Number: TL010 - 2024

Subject: Undermount Genset (UG) Mounting Instructions

Released: September 19, 2024

This TechLINE is an update to the installation procedure when mounting the UG to the chassis.

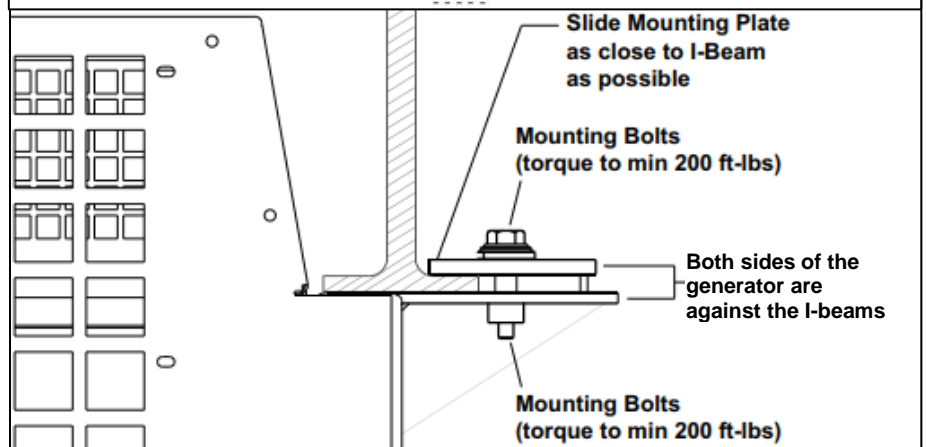
Slide Mounting Plate as close to I-Beam as possible

Mounting Bolts (torque to min 200 ft-lbs)

Both sides of the generator are against the I-beams

Mounting Bolts (torque to min 200 ft-lbs)

NOTE: It is important to ensure the forklift is removed when checking torque on the genset. Keeping the forklift installed can cause a false torque reading due to the forks holding the unit down, possibly resulting in the unit not being properly secured to the chassis.
